## DESCRIPTIVE REPORT

*Type of Survey* Hydrographic  
*Field No.* H11824  
*Registry No.* \_\_\_\_\_

*State* Alaska  
*General Locality* Ernest Sound  
*Sublocality* Vicinity of Vixen Inlet

Project OPR-O119-FA-09  
Ernest Sound & Eastern Passage, AK

**Figure 16: Sounding Plot and Subset around charted ¾ fm shoal**

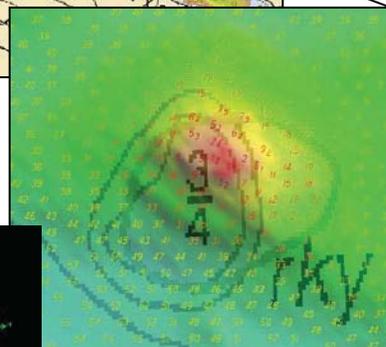
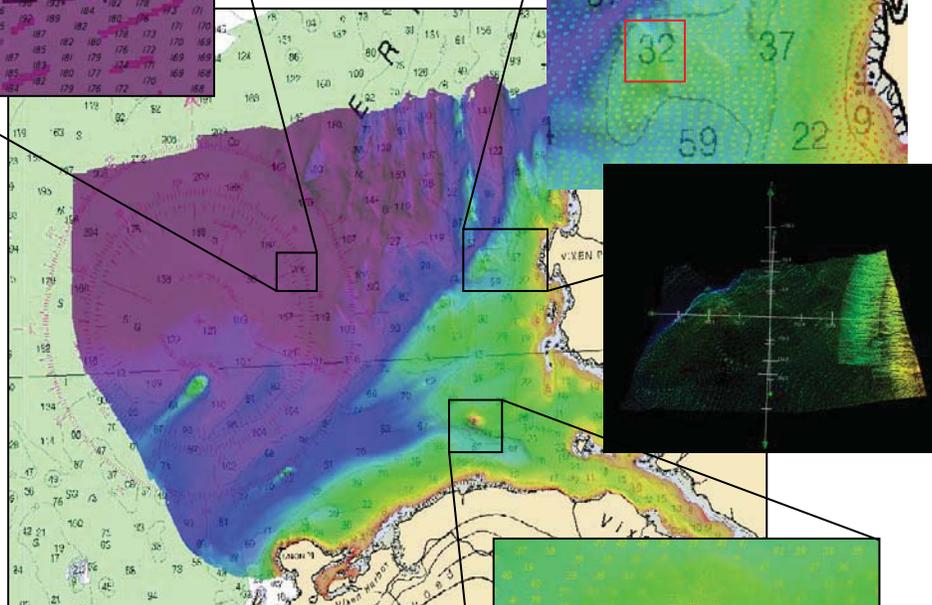
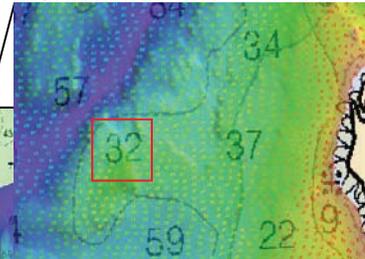
- 208 fm charted sounding surveyed 10-15 fathoms shoaler (Figure 14) *Concur*
- 32 fm charted sounding surveyed at 26 fm (Figure 15) *Concur.*
- ¾ fm shoal extent portrayed inaccurately. Chart at surveyed extents. (Figure 16) *Concur with clarification. Submitted UWTRC at location Latitude 55-49.23.29N and Longitude 132-07-14.63W portrays more accurately the shoal within the area.*

**Figure 18: Sounding plot and subset of area around 26 fm charted sounding**

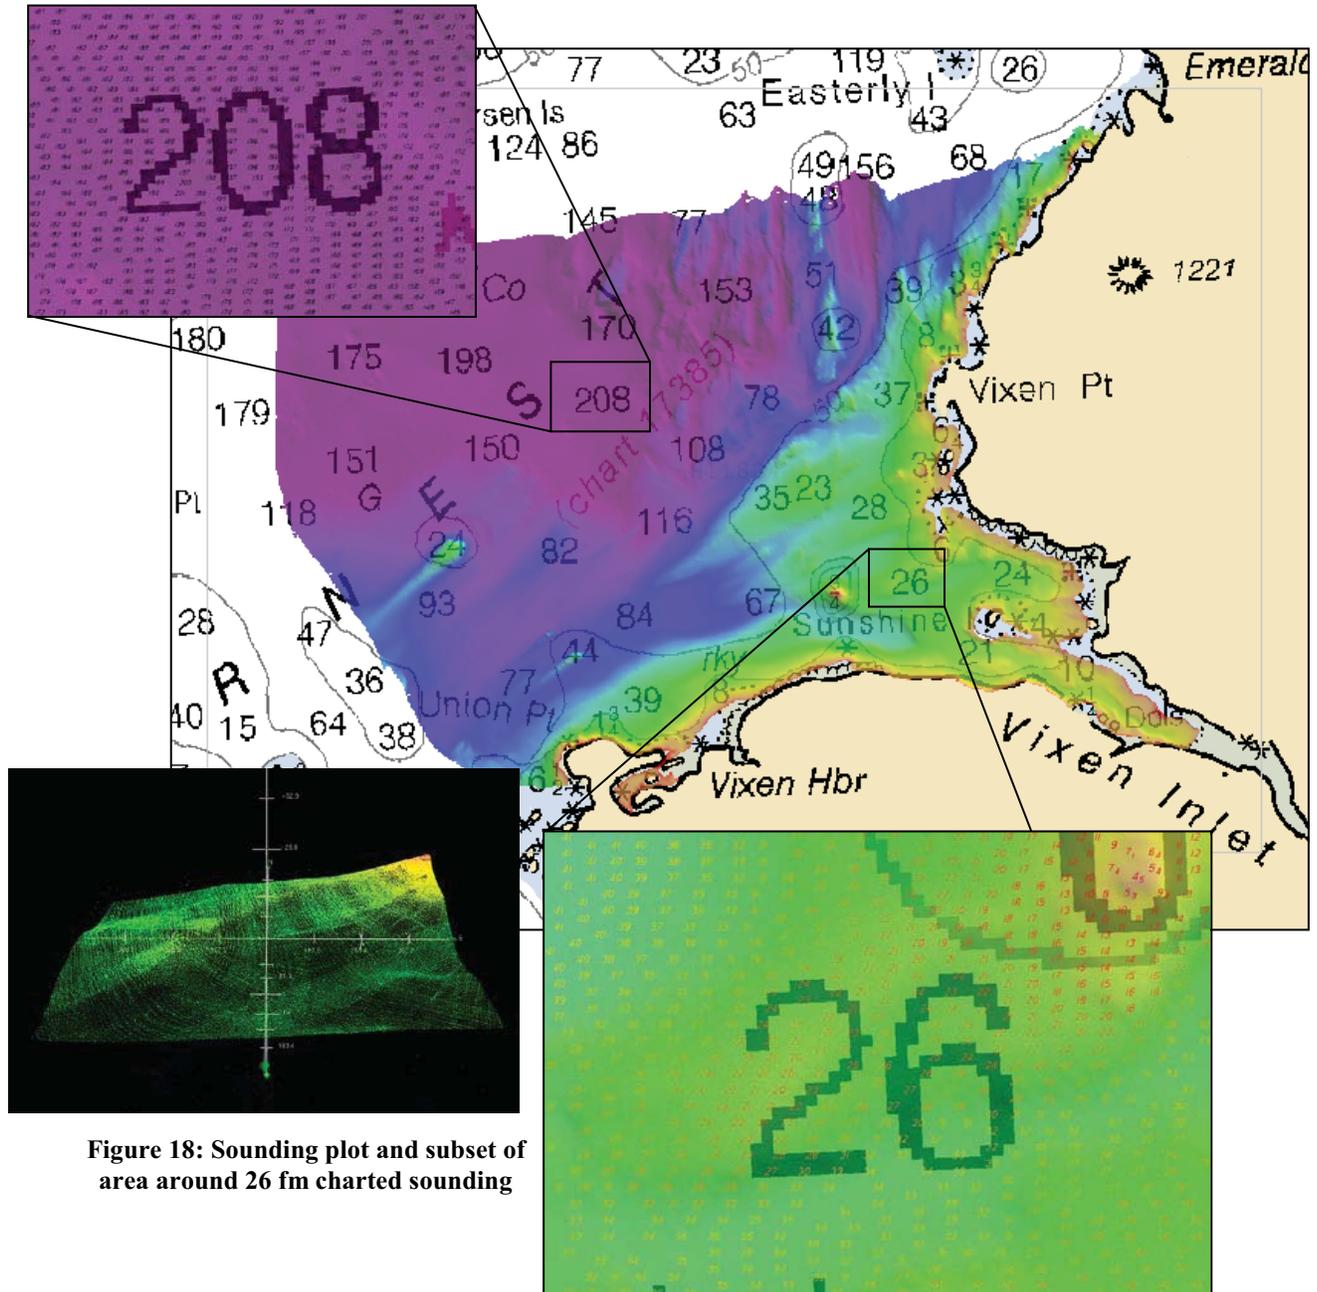
- 208 fm charted sounding surveyed from 170 – 201 fathoms (Figure 17) **Concur**
- 26 fm charted sounding surveyed at 20 fm (Figure 18) **Concur**

Figure 19: Sounding Plot and Subset around 1 ¼ to 15 fm shoal

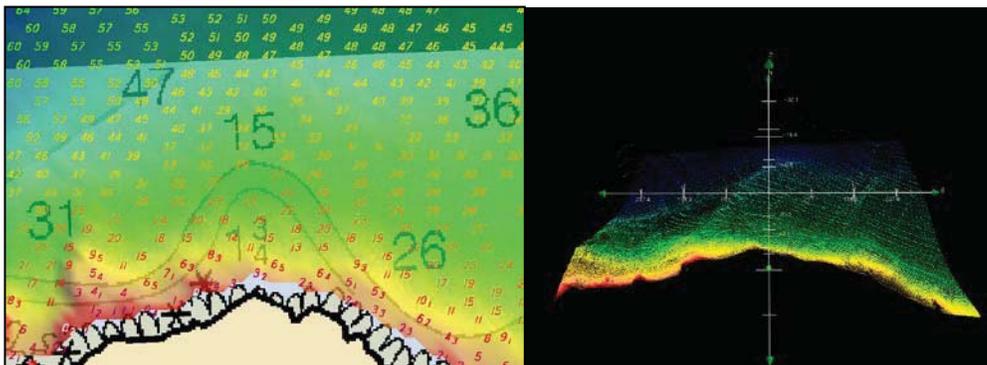
- 15 fm to 1 ¼ fm shoal mis-charted. Chart surveyed soundings (Figure 19) **Concur**

Figure 20: Sounding Plot of Vixen Harbor

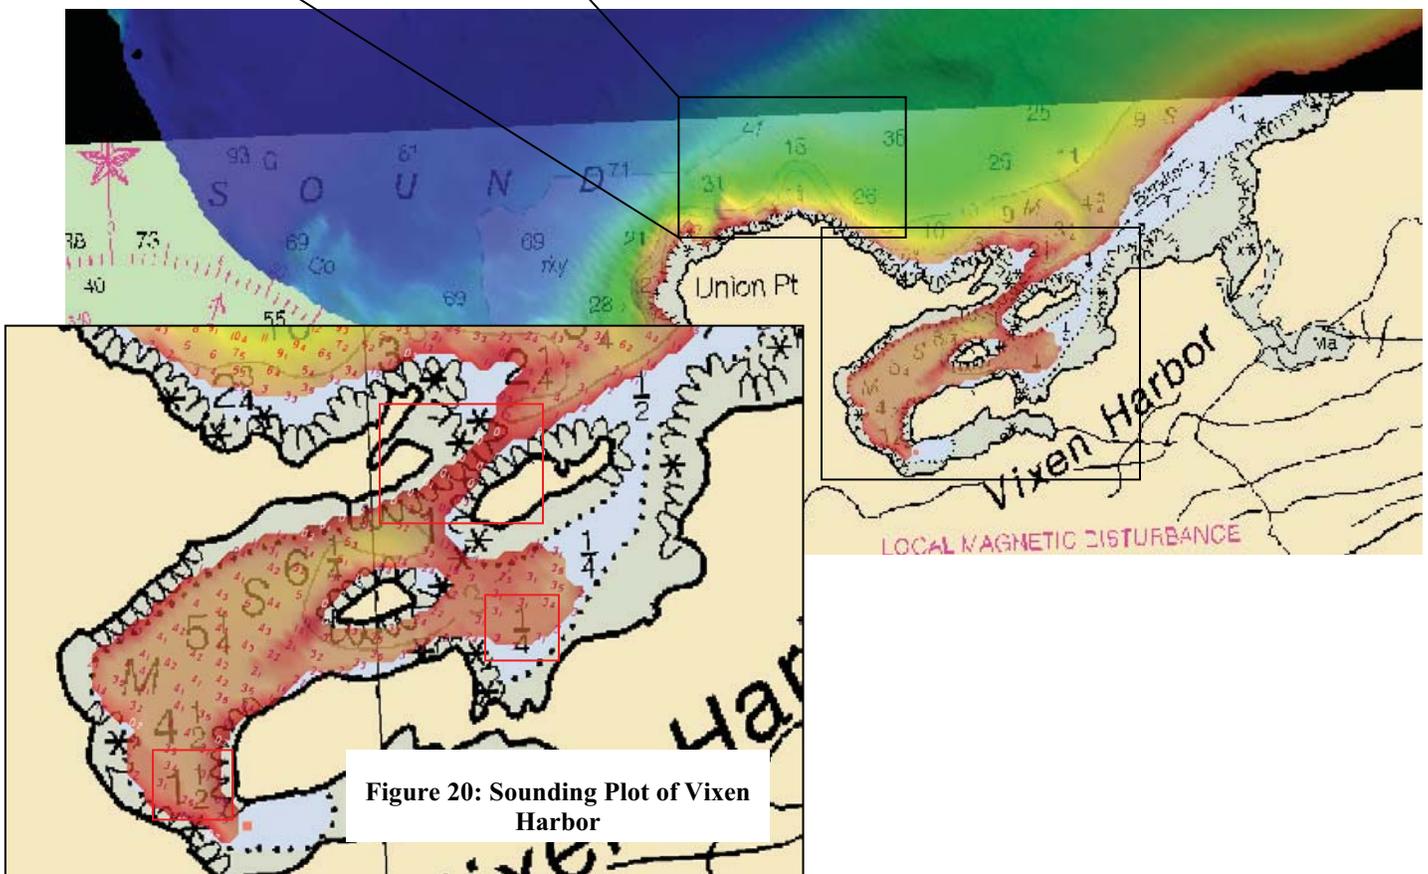
Chart 17423 does not accurately represent Vixen Harbor at the charted scale. It is the recommendation of the Hydrographer that an inset be made on the published chart for Vixen Harbor due to the harbor’s narrow, shoal entrance and the harbor’s verified use by fishing vessels. Figure 20 depicts how the charted depths do not represent the surveyed area. **Do not concur. Due to the extremely shoal depths in Vixen Harbor’s entrance, the office does not recommend an inset be made due to concern for mariner’s safety.**

It is the recommendation of the Hydrographer that an inset be made on the published chart for Vixen Harbor due to the harbor's narrow, shoal entrance and the harbor's verified use by fishing vessels. Vixen Harbor being well sheltered also makes it a prime small boat anchorage. *Do not concur. Due to the extremely shoal depths and obvious danger in Vixen Harbor's entrance, the office does not recommend an inset be made due to concern for mariner's safety.*

**Figure 21: Example of MBES coverage over charted ledge to the extent of prior survey features**

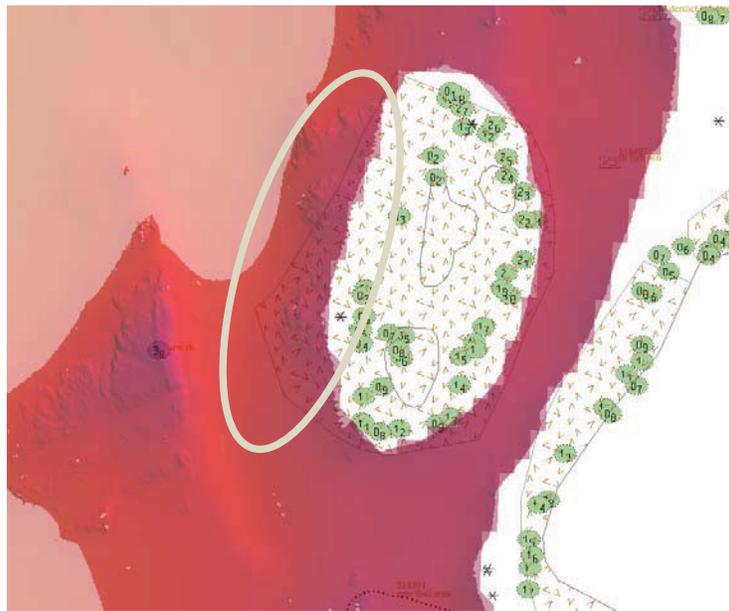
Numerous extents of sections of the shoreline (ledges) are in conflict with hydrography, see Figure 21 for an example. After discussion with representatives from the Pacific and Atlantic Hydrographic Branches, it has been decided to leave the ledge area features intact for processing branch personnel to manage. In many cases the Prior Survey Features (psf) more accurately represent the ledge than what is currently charted. The psf have been extracted from the Final Feature File and will be submitted with the other deliverables as a separate file H11824\_Prior\_Survey\_Features.hob\*\* to help aid the branch in partially disproving the charted ledge.

*Concur with clarification. Each shoreline ledge feature will be addressed in H11823 H-Cell.*
